SUBJECT: WESTINGHOUSE RESPONSES TO NRC REQUESTS FOR ADDITIONAL
INFORMATION ON THE AP600

Enclosed Responses to NRC Requests for Additional Information

Enclosure 2 to Westinghouse Letter NTD-NRC-95-4594

NRC REQUEST FOR ADDITIONAL INFORMATION

Figure 440.435-1 Supply Tank Pressure.

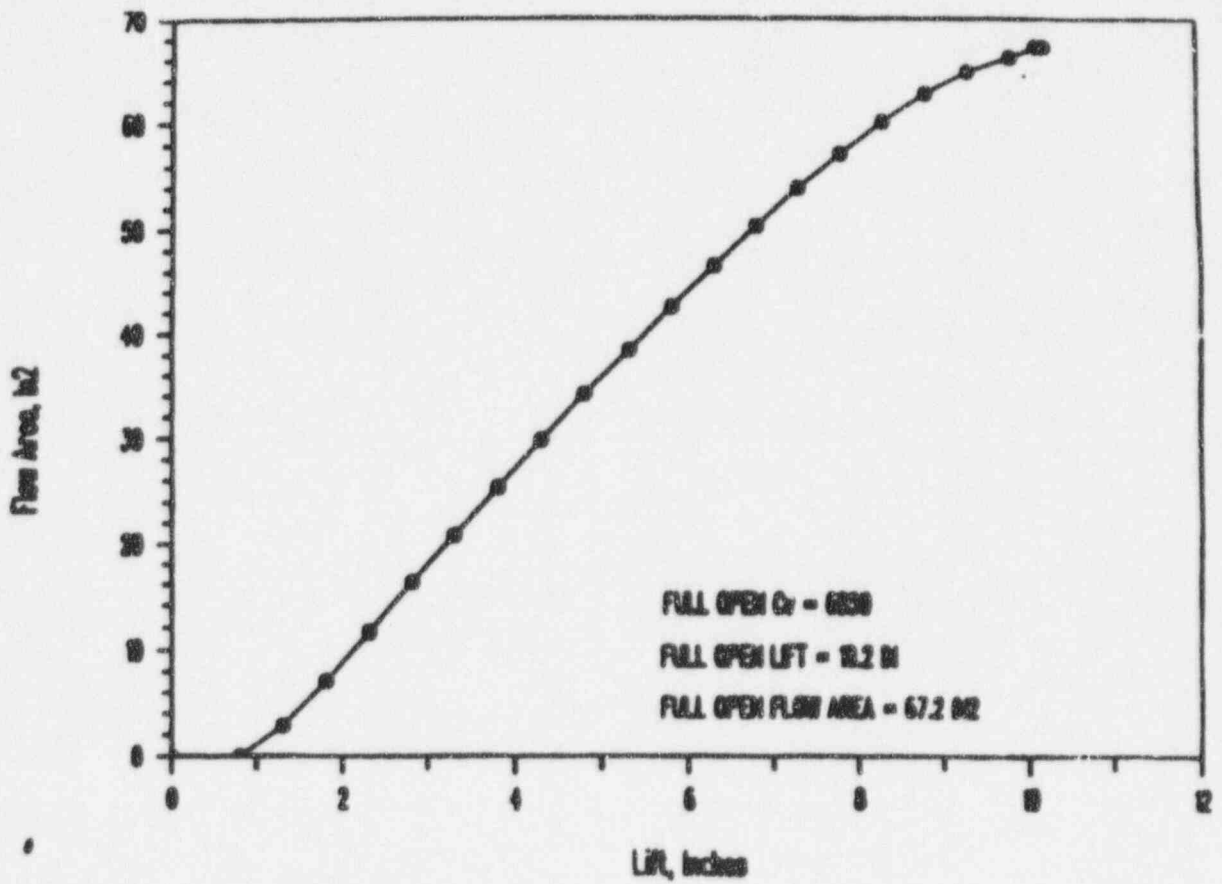
The flow quality data show an increase in quality within the first six seconds for all of the tests while NOTRUMP displays a decreasing trend. While the flow quality at the sparger discharge will establish the depressurization rate for the system, the miscalculated flow quality, particularly in the beginning of each test, suggests that NOTRUMP is lacking dynamic effects. As such, explain how the two-region fluid model void distribution in the liquid regions is computed, and how this lower region void fraction affects the quality exiting a volume. Also, does the assumption that steam regions form above liquid regions affect the fluid void distribution in the ADS lines? That is, explain the conditions where separation occurs versus highly dispersed liquid-steam mixture conditions with void gradients and how NOTRUMP treats these conditions in the ADS lines. Are void gradients computed in the liquid regions? How is the release of steam from the liquid region computed; is it based on the average void fraction in the region or is a surface void fraction computed for release calculations? In vertical sections, during depressurization transients or vertical regions with high heat addition, large void gradients can develop where the surface void fractions can be two to three times greater than the average. Please explain how NOTRUMP treats the void distribution and release of steam from the two-phase regions under these conditions?

Figures 440.435-1 and 440.435-2 show that in ADS Test 240 both the pressure and the mass in the supply tank are constant in the first 3.5 seconds, then decrease after 3.5 seconds. This means that VLI-1 gate valve did not open at time zero, rather it actually opened at 3.5 seconds. There are many reasons for this. First, the valve was initially very tightly closed. Therefore, when the power was applied to the gate valve, it took a period of time before the valve began to move. After the valve began to move, it took additional time to clear the seat and actually open sufficiently to allow flow to pass. Because of the shape of the gate valve, the valve opening area did not increase linearly at first, but increased very slowly, then gradually increases linearly increase as can be seen in figure 440.435-3. This is reflected in the pressure plot (Figure 440.435-1) and mass plot (Figure 440.435-2), where the curves change gradually, instead of sharply changing, at 3.5 seconds when the valve is open.

In the NOTRUMP simulation, the valve is assumed to open linearly from the time zero. To have a comparison between the NOTRUMP calculations and the data, it is necessary to find the effective opening time of the valve in the test. This is accomplished by intersecting the linear portion of the pressure curve (Figure 440.435-1) with the initial horizontal line, which is 3.5 seconds. Therefore, the comparison of Test 240 in reference 440.435-1 should be corrected by shifting the data curves to the left by 3.5 seconds so that the actual VLI-1 valve opening time is at time zero. The results are shown in Figures 440.435-4 through 440.435-13 (The original unshifted plots in reference 440.435-1 are shown following each shifted plot). It is seen that the agreement between the NOTRUMP calculated quality and the quality calculated from the data is much better. A similar time shift is applicable to other tests.
